### 3.4 Instrumentation and Control

The information in this section of the reference ABWR DCD, including all subsections, tables, and figures, is incorporated by reference with the following departure.

STD DEP T1 3.4-1

Figure 3.4a Safety System Logic and Control (SSLC) Control Interface Diagram

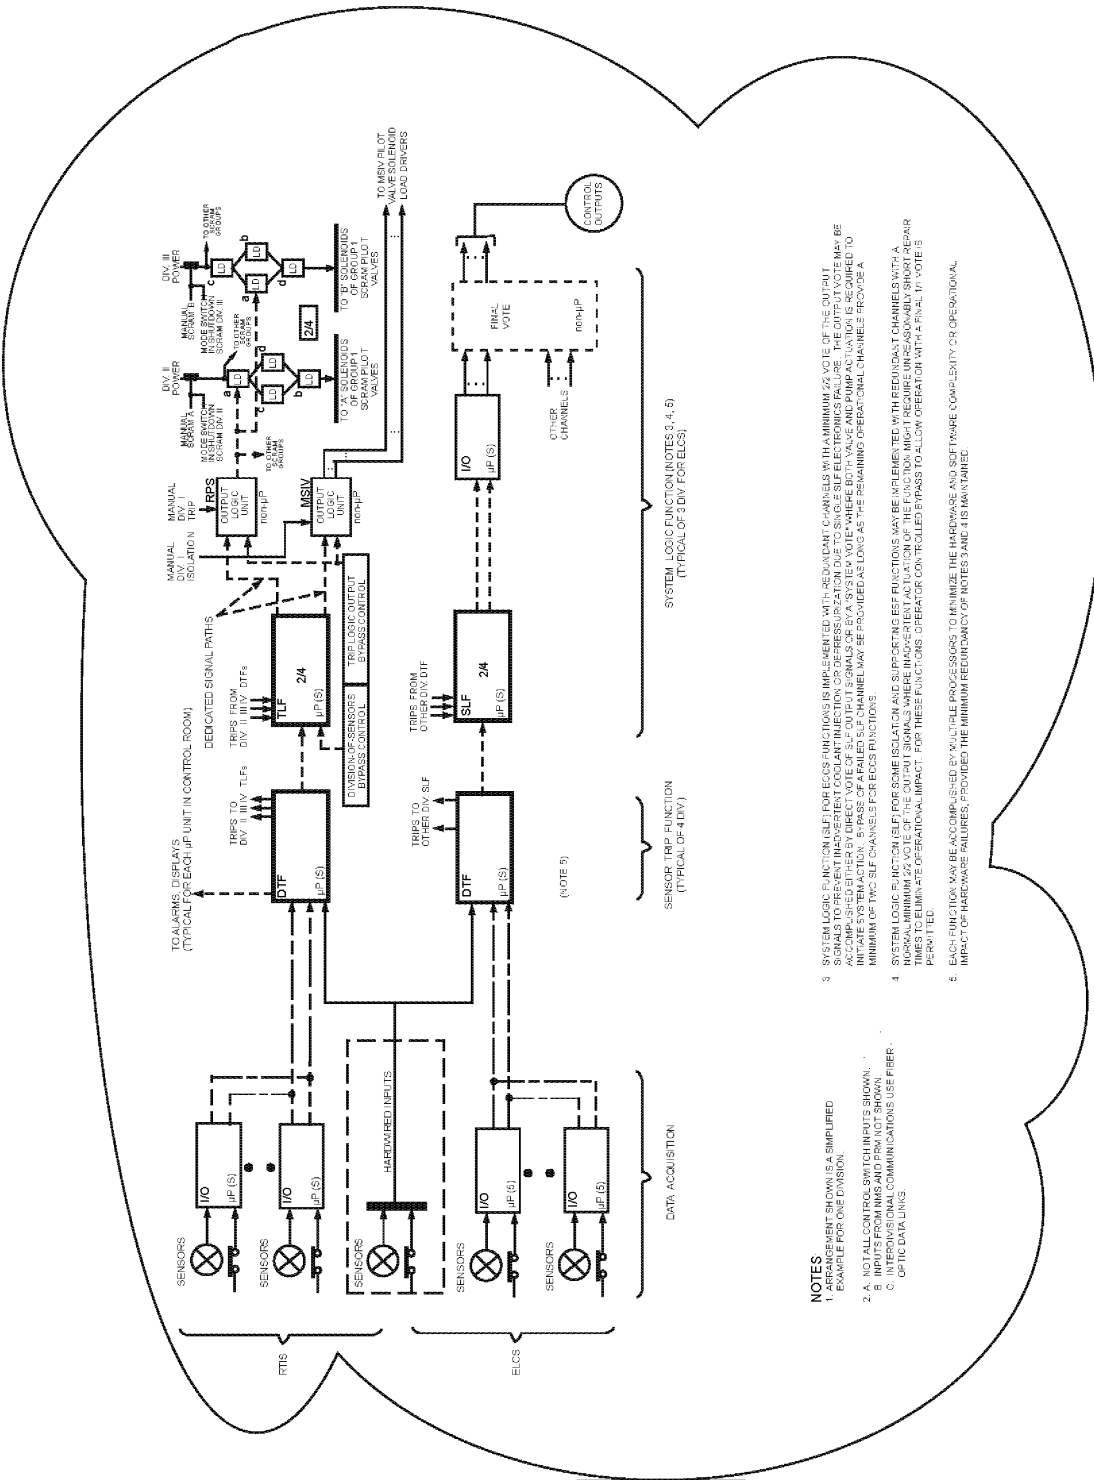
*~~Safety related monitoring and trip logic for the plant protection systems resides in SSLC equipment. SSLC integrates the automatic decision making and trip logic functions and manual operator initiation functions associated with the safety actions of the safety related systems.~~ Safety System Logic and Control (SSLC) is a general term that encompasses the logic and controls associated with safety-related systems. This includes automatic and manual protection and control functions. ~~SSLC generates the protective function signals that activate reactor trip and provide safety related mitigation of reactor accidents.~~ SSLC is primarily implemented through the Reactor Trip and Isolation System (RTIS), which supports the reactor protection and main steam isolation functions, and the ESF Logic and Control System (ELCS), which supports the accident mitigation functions. Also included in SSLC are the Neutron Monitoring System (NMS), the Containment Monitoring System (CMS) and the safety-related portions of the radiation monitoring systems. The relationship between SSLC and systems for plant protection is shown in Figure 3.4a.*

~~The basic hardware functional configuration for one division of SSLC is shown in Figure 3.4b. Each division runs independently (i.e., asynchronously) with respect to the other divisions. The following steps describe the processing sequence and associated function descriptions for incoming sensor signals and outgoing control signals. These steps are performed simultaneously and independently in each of the four divisions:~~

Figure 3.4b Safety System Logic & Control Block Diagram

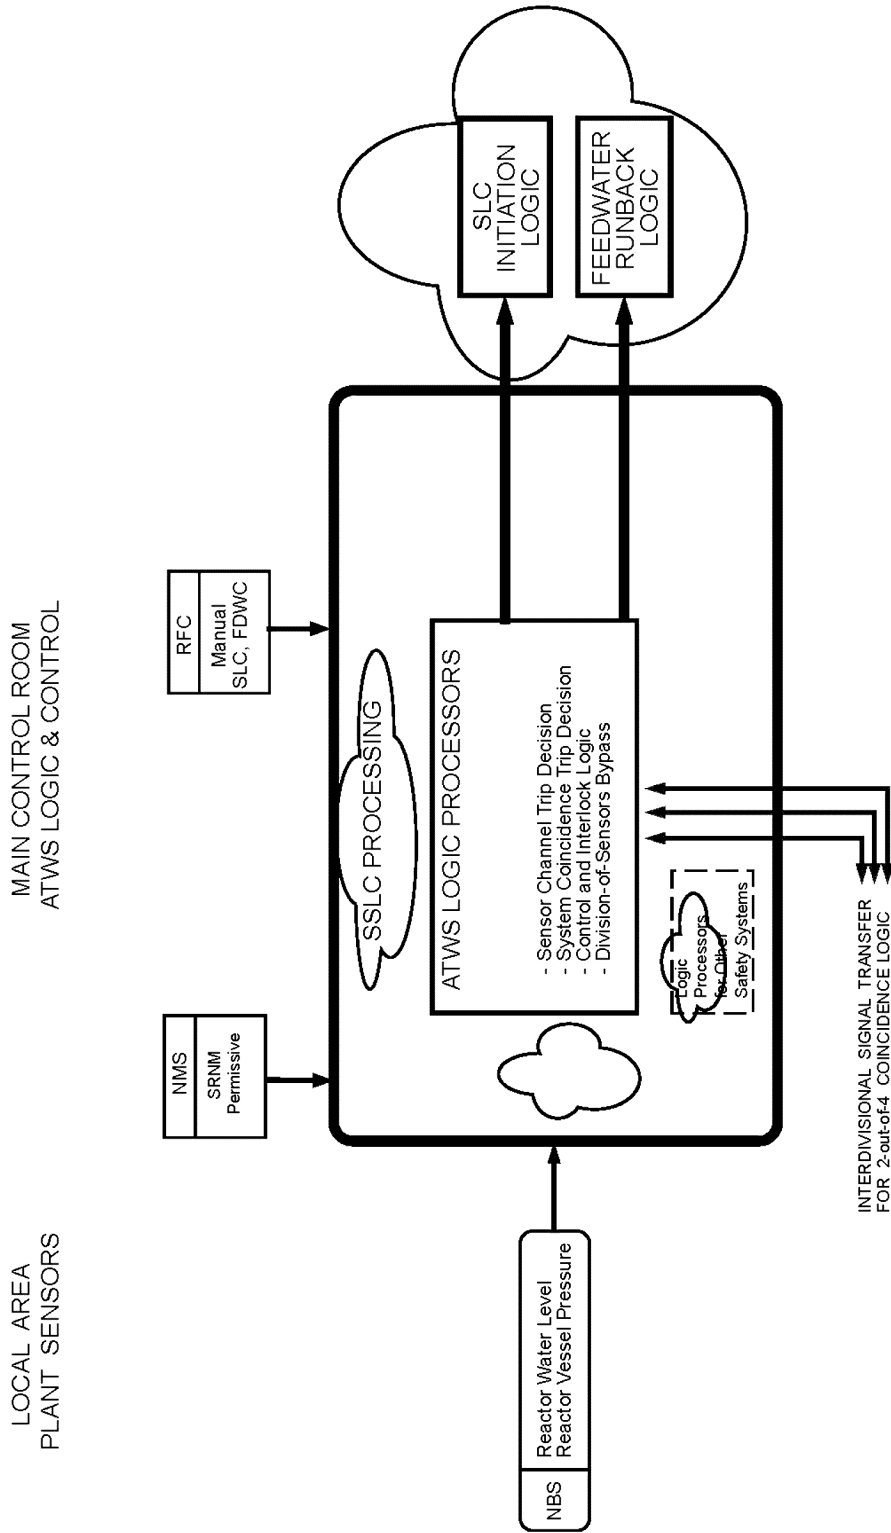
~~As shown in Figure 3.4b, a pair of SLU are located in each of two engineered safety feature (ESF) processing channels, ESF1 and ESF2. ESF1 processes initiation logic for functions which service the reactor vessel at low pressure (e.g. RHR), while ESF2 provides the same support for the~~

~~vessel at high pressure (e.g. Reactor Core Isolation Cooling (RCIC) System and High Pressure Core Flooder (HPCF) System). Associated LDS and ESF functions are also allocated to these logic channels.~~
